Technical Advisory Bulletin (TAB)

Bulletin #: TBMELCO016A

Product: Melco EMT16, BRAVO

Subject: Needle 16 dropping

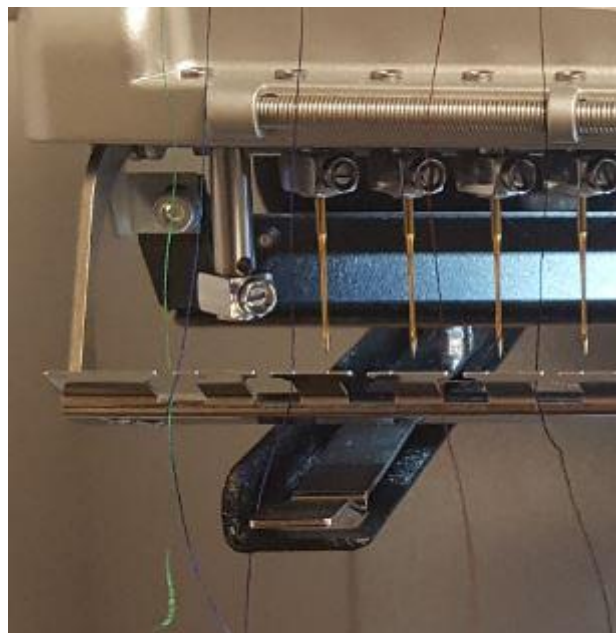
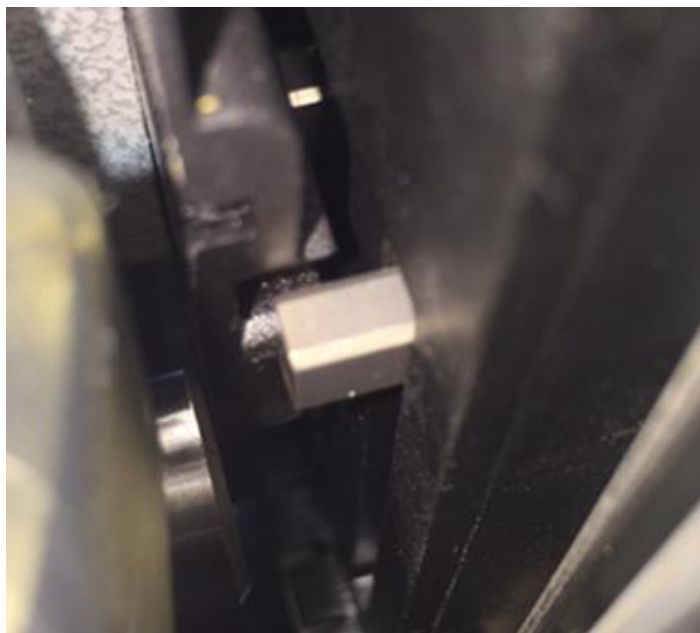
When the Needle Case reaches this far left position, the Needle Bar Stud on Needle #16 is positioned very close to the left end of the guide channel in the Left Front Upper Arm Cover, or even protrude out of this channel. See picture below.

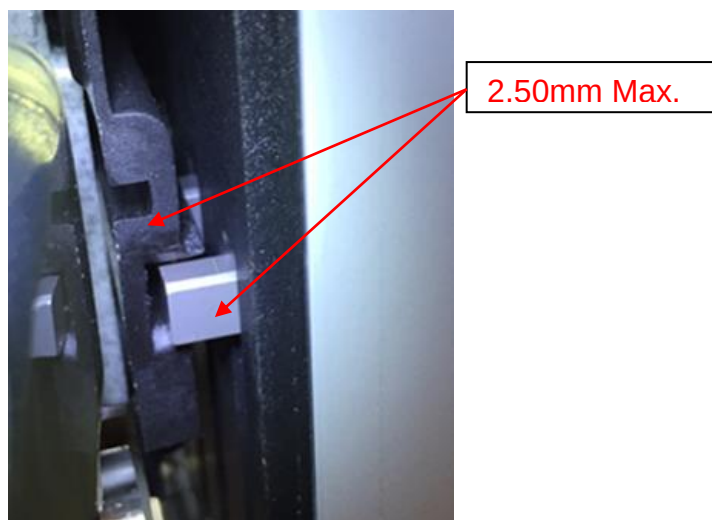
In extreme cases, if the Needle Bar Stud travels beyond the end of the Front Arm Cover, Needle16 will drop as shown below.

Currently, all factory machines are correctly assembled to prevent this issue from occurring. In addition, all machines in inventory at Melco have been checked for this condition and corrected as required since detection of this defect.

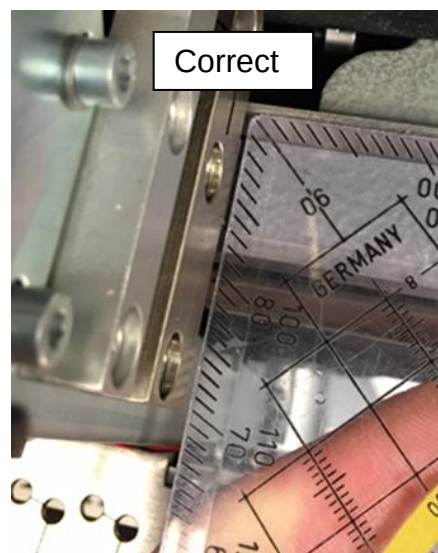
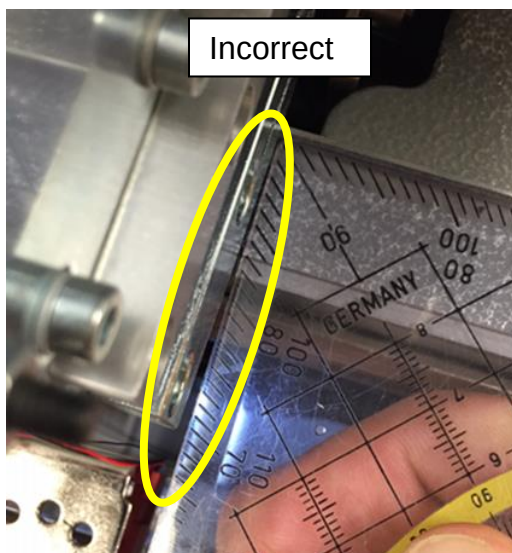
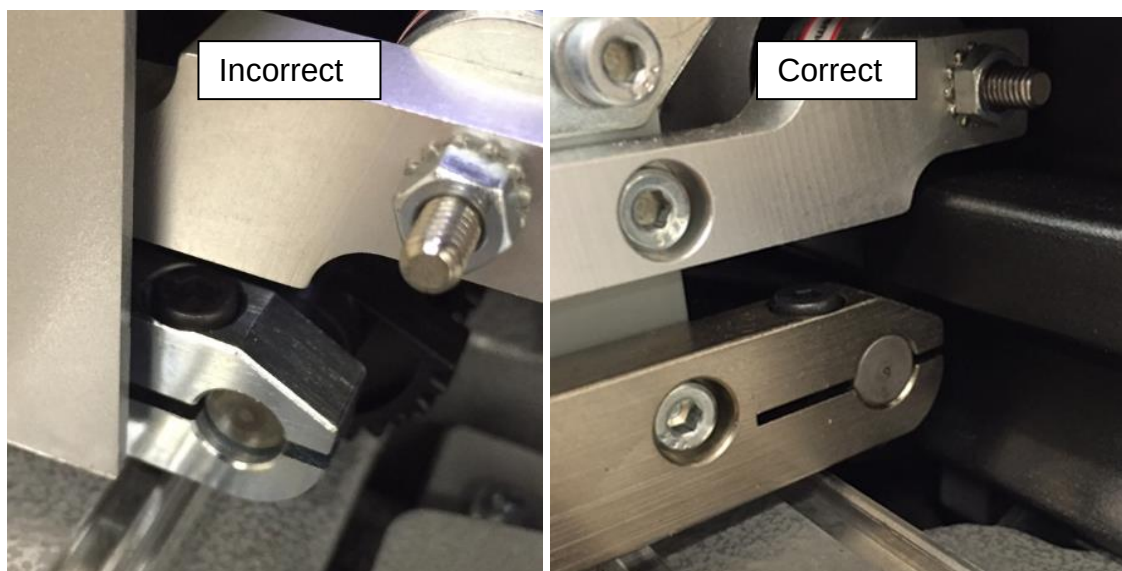
4. For machines at Melco Switzerland/Germany, measure the distance the number 16 Needle Bar Stud protrudes beyond the left side of the Left Upper Arm Front Cover. If the measurement is more than 2.5mm, it is recommended that the Needle Case Assembly be re-adjusted to reduce this distance. Only Melco trained technicians are recommended to perform this readjustment.

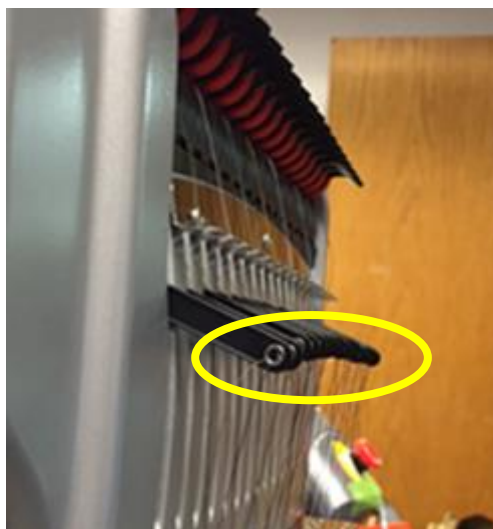
5. **Technicians Only:** The cause for this issue is mostly the result of the Take-Up Lever Mounting Bracket on the right side of the Needle Case Assembly not being square or perpendicular to the Upper Head Casting. The right side of the Needle Case Frame is bent outwards and the Take-Up Lever Shaft is recessed as shown in the pictures below.

During the process of correcting this issue the Take-Up Levers, Color Change and Thread Feed assemblies will all require readjustment to machine specifications.
